## FINAL DESIGN SUBMISSION

National Capital Planning Commission  
06 April 2017

### *Smithsonian's National Zoological Park* Renew Bird House Facility - Experience Migration on Bird Plateau

## CFA and SHPO Comments and Responses

Layout Plan - North Entry

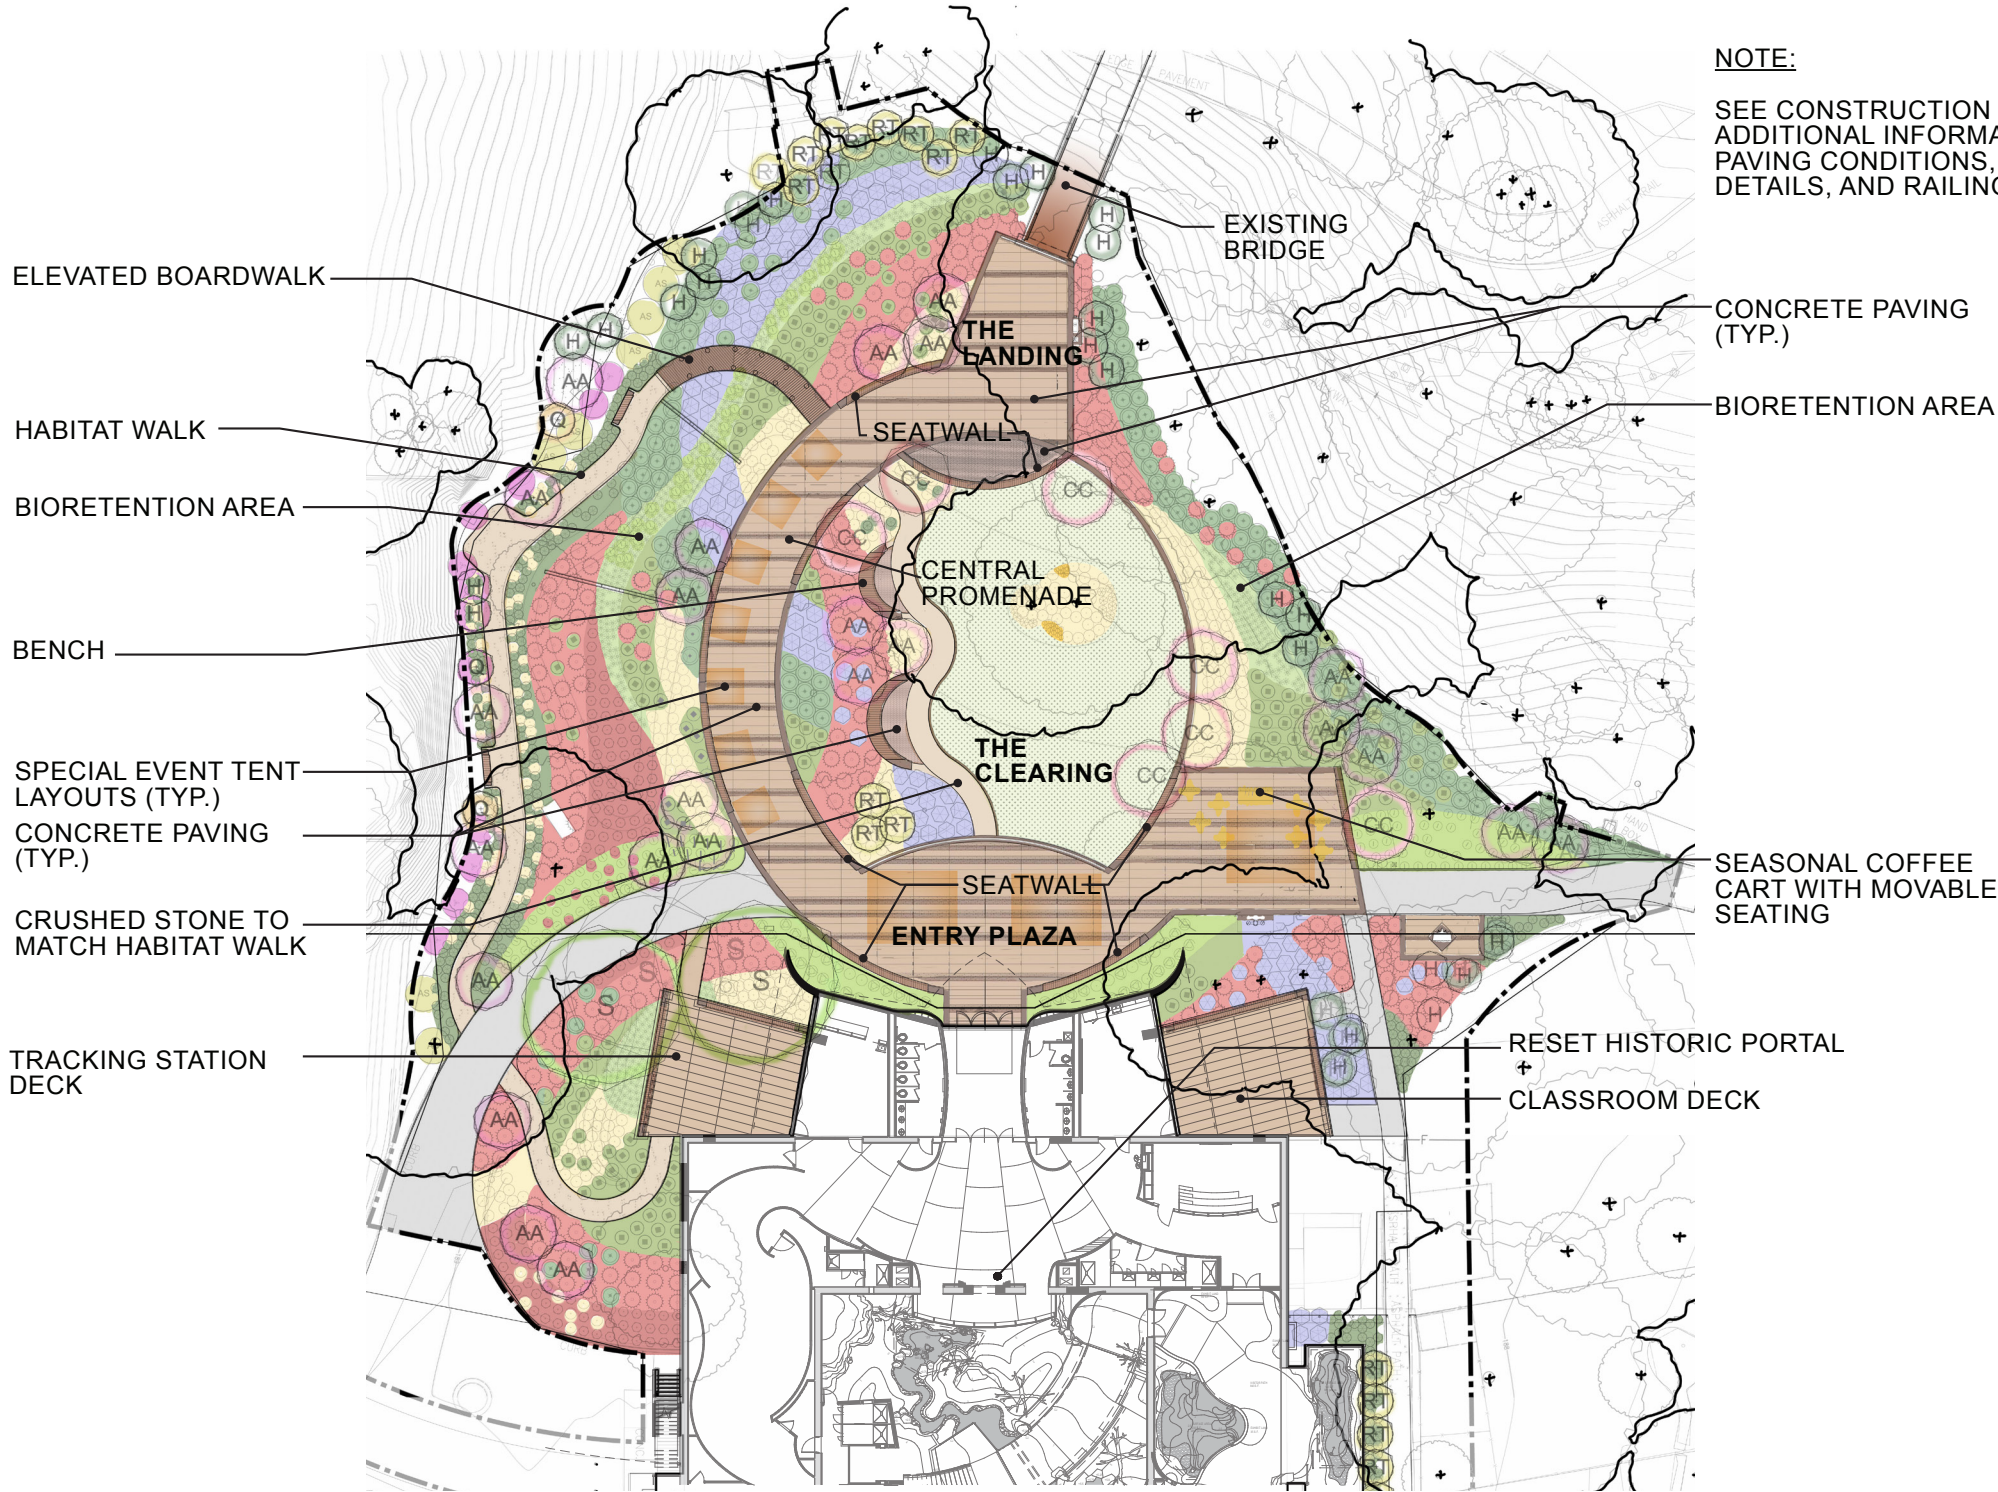
- "...questioned the inward curve of the bench on the northern edge of the oval..." (CFA July 29, 2016)
  - *Design Team Response: After investigating the design approach of a completed oval, the design team felt strongly that the inward curve approach was an appropriate solution for the northern edge of the site. (Dec. 08, 2016)*

- The north bench concave curvature may be balanced through the use of paving material and color to complete the overall oval form of the main walkway. (CFA Dec. 13, 2016)

- "Perhaps, the curved bench should be recessed and follow the curve of the oval instead of the inward curve as shown in the proposal." (CFA Feb. 1, 2017)

- Consider use of a less formal, more uniform paving material at the serpentine pathway. (CFA Dec. 13, 2016)
  - *Design Team Response: The serpentine path is an important component of the Habitat trail that connects the Clearing to the entry plaza, Tracking Station deck and the westerly plant pollinator garden. The material of the serpentine path and habitat trail is crushed stone surfacing. At the serpentine path, its eastern edge along the lawn has been refined to be a flush concrete header that acts as a mow strip and assists in keeping loose stone out of the lawn. The area in front of benches is designed as precast pavers to withstand higher wear and tear that would occur from moving feet of visitors sitting on the bench that would otherwise create a divot if designed as crushed stone surfacing. (Jan 13, 2017) Page 26.*

- *Design Team Response: The bench and elliptical extension of Landing south into the Clearing provides an eddy gathering area out of the main path. Paving materials continue the line of the ellipse of the promenade to the north of the bench completing the shape of the ellipse. The eddy seating area paving is precast unit pavers. (Jan 13, 2017) Page 26.*

- *Response: Previous review and response from CFA Staff support the curved bench as presented in the proposal. (Feb. 2, 2017)*

Planting Plan - North Entry

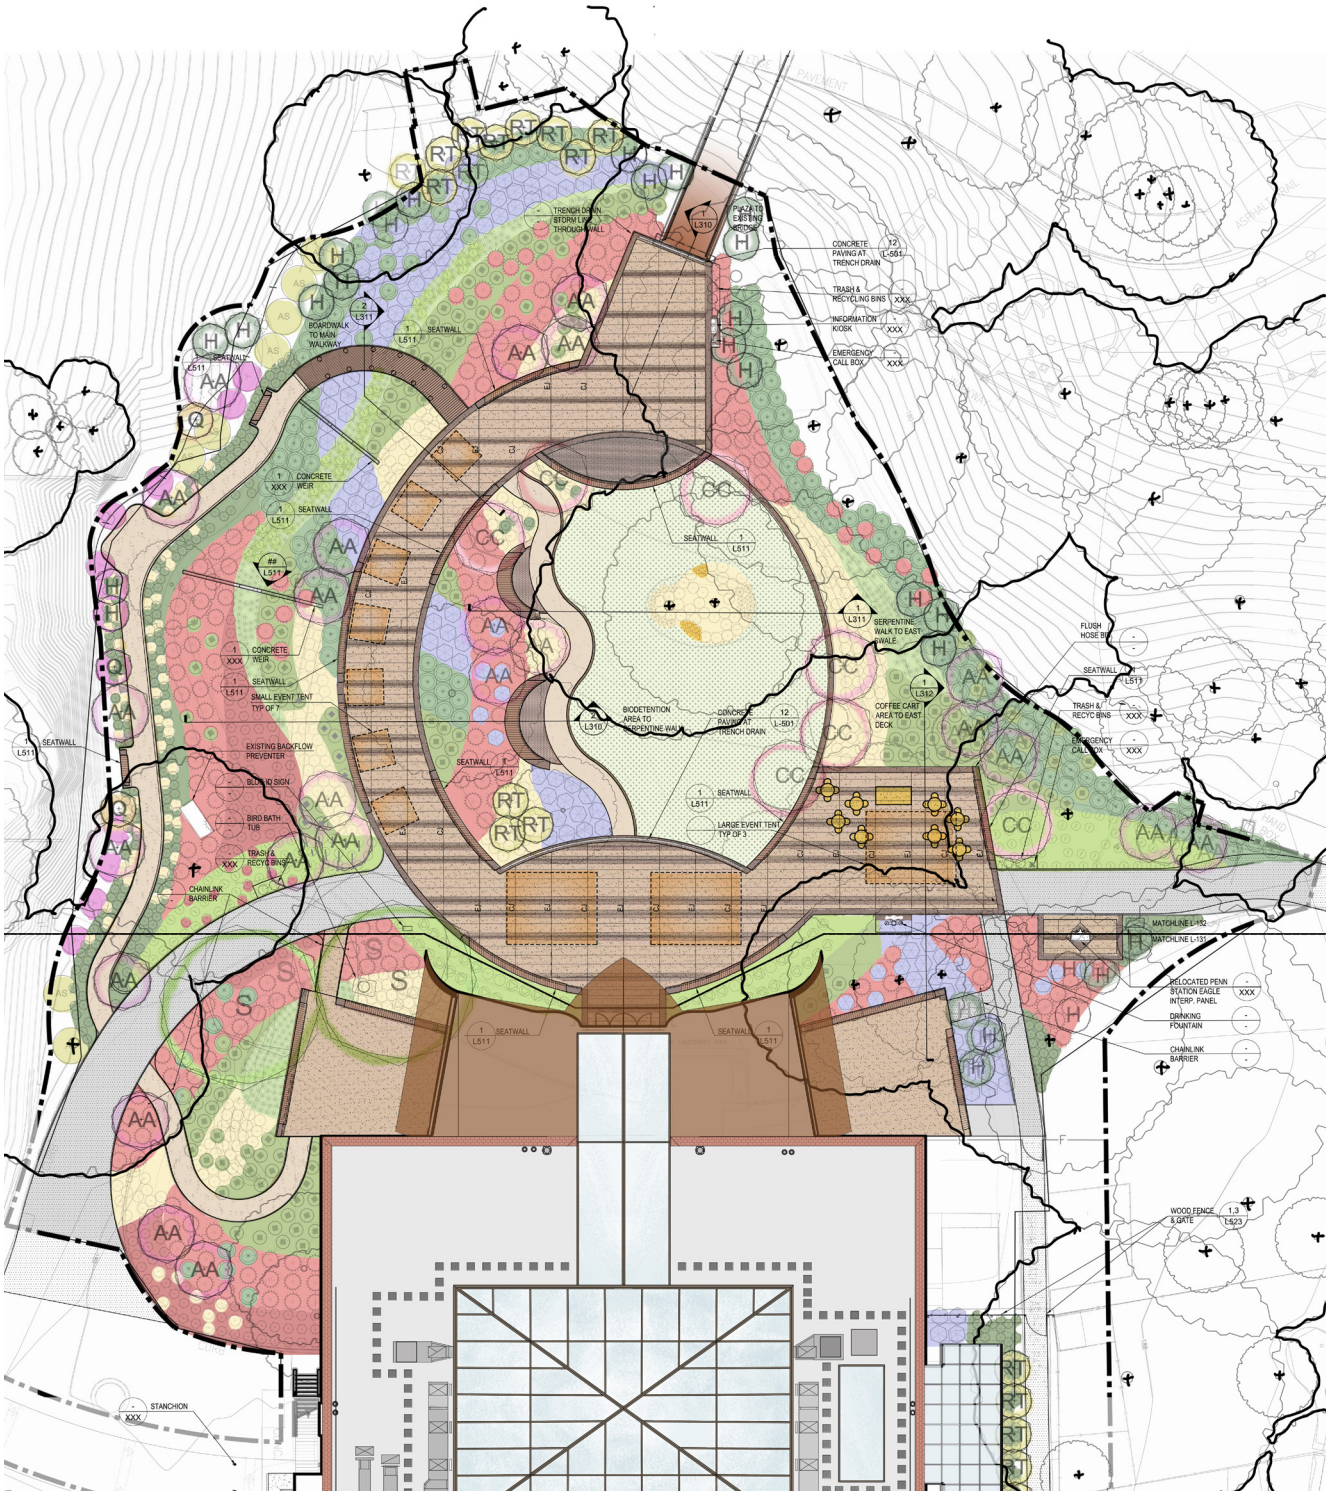
- "Consider adding more trees in the vicinity of the entry from the bridge to form a small grouping." (CFA Dec. 13, 2016)
  - *Design Team Response: A primary function of the Landing, Promenade and Entry Plaza is to provide space for Zoo and FONZ-sponsored special events. This includes a requirement for open paving to install a variety of temporary*

- "Were there any other configurations for the area on the north side of the oval studied that could be accommodate the additional trees?" (CFA Feb. 1, 2017)
  - *Design Team Response: A number of different design iterations were studied to accommodate the recommendation of "interspersing trees within the paves area" in order to "extend the woodland setting and provide shade for the visitor comfort". These studies are dated and have been provided for your review and reference. The placement of the trees within the paved areas was deemed infeasible by the NZP horticulture and maintenance department, stating concerns for the long term health of the trees and visitor experience. Please reference memo dated Jan 19, 2017 from Jennifer Daniels at the Smithsonian Institute NZP for further clarification on this comment. (Feb. 2, 2017) Page 27.*

*tent sizes and functions. The attached site plan indicates dashed rectangles along the Promenade for vendor tents. Larger tents for seating are shown at the Entry Plaza and Café terrace. Additional trees have not been placed within the Promenade paving because of this essential program requirement.*

*The site design for the north entry is an interplay between the formal geometry of the Birdhouse entry axis and elliptical shape of the Promenade, and the informal, bird murmuration and successional inspired planting plan. A grouping of three redbud trees has been developed at the landing bench and entry to the Serpentine Path frame the important axial view of the Bird House. The trees are slightly offset and relate to a grouping of four redbud trees at the Café Terrace. (Jan 13, 2017) Page 27.*

Historic Portal Perspective - Brick Surround

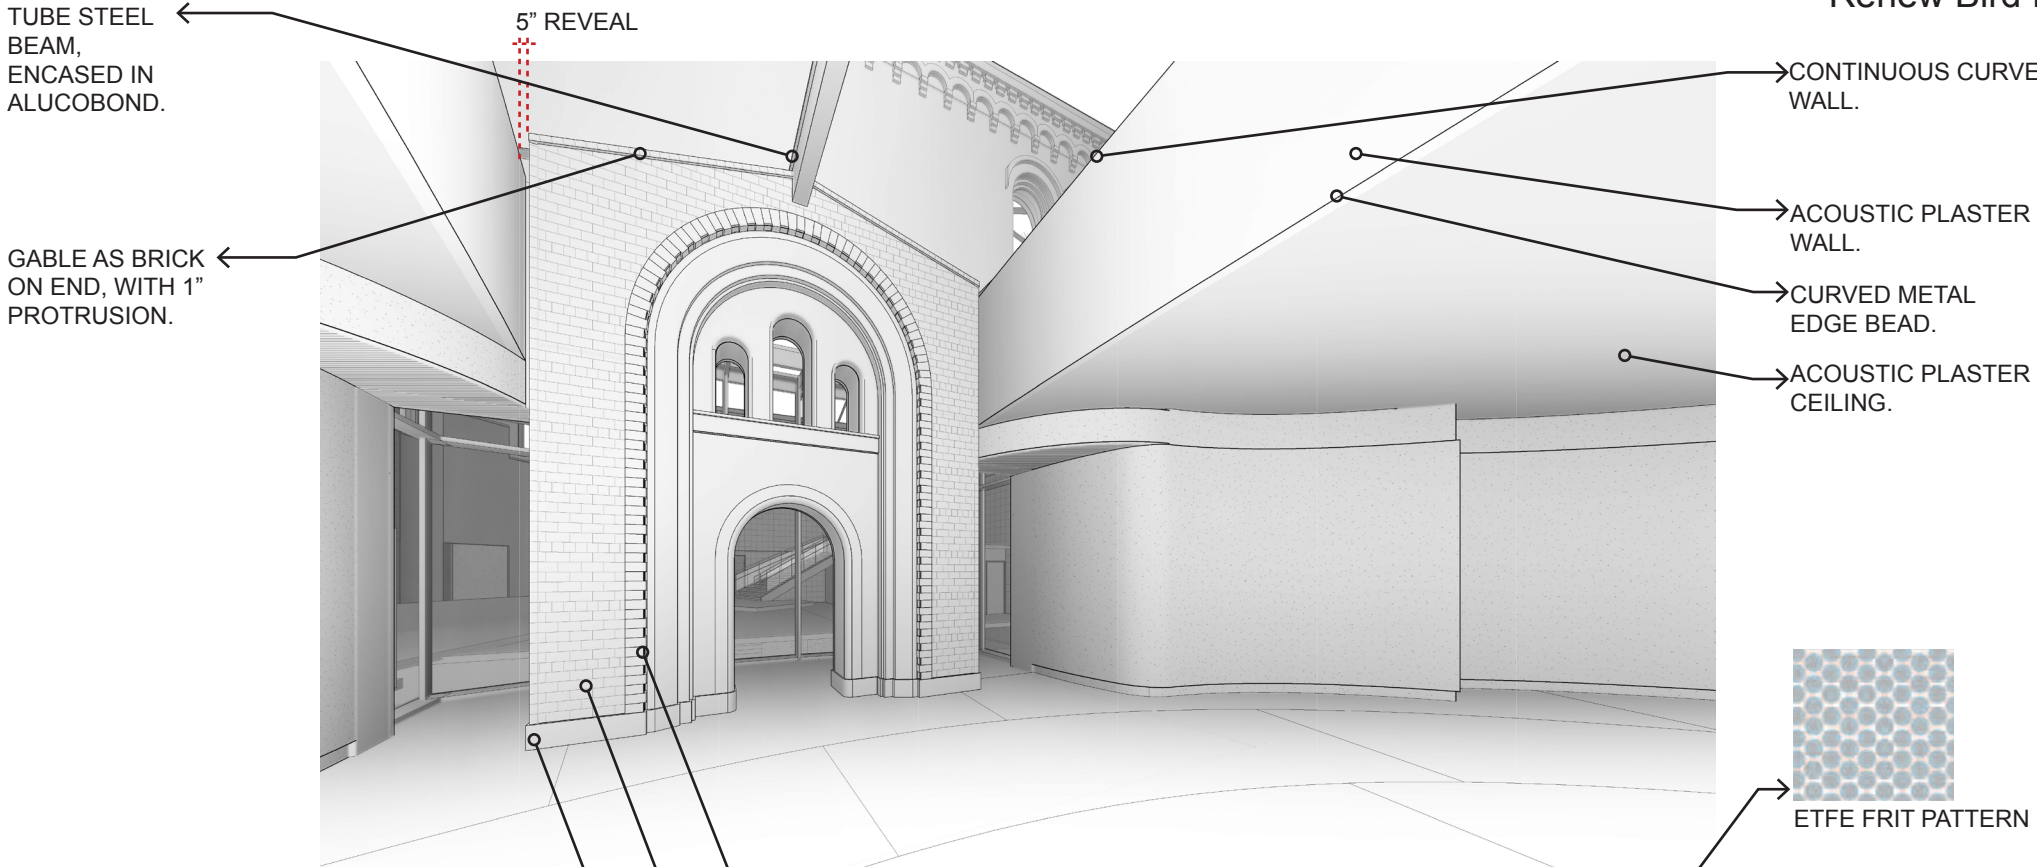
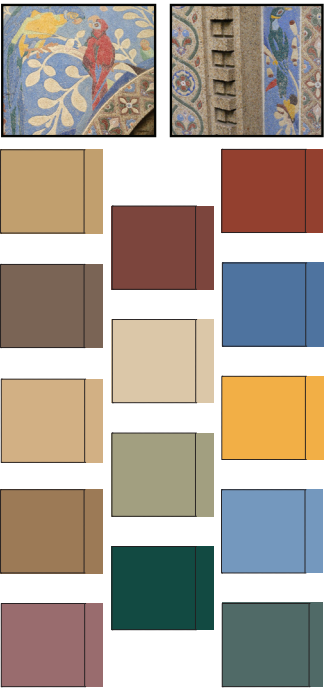
- "...will frame the J.J. Early concrete door surround so that the wall is more evocative of the door surround's original setting (i.e. the historic exterior brick of the Bird House). The selected finish does not necessarily need to be brick, but whatever material or finish is ultimately selected should suggest the color and texture of the historic brick.." (SHPO, July 29, 2017)

- "...providing a suitable transition between the surround material and portal fabric, the materiality and perceived mass of the surround, suggesting a closer affinity with the historic masonry above." (SHPO, Dec. 13, 2016)

- *Design Team Response: The wall surround of the historic concrete portal is proposed to be a venetian plaster material in a color that is sympathetic to that of the historic masonry. (Dec. 08, 2016).*

- *Design Team Response: Three options for the design of the portal setting have been investigated to address the above. The preferred option illustrates the portal surround comprised of face brick with sympathetic (but identifiably new) hue, coursing, and detailing to the historic masonry. The transition between surround and portal is addressed by an arched soldier course. (Jan. 13, 2017)*

- "...agree that the final finish will be [the preferred option]." (SHPO Jan. 27, 2017) Page 33-34.
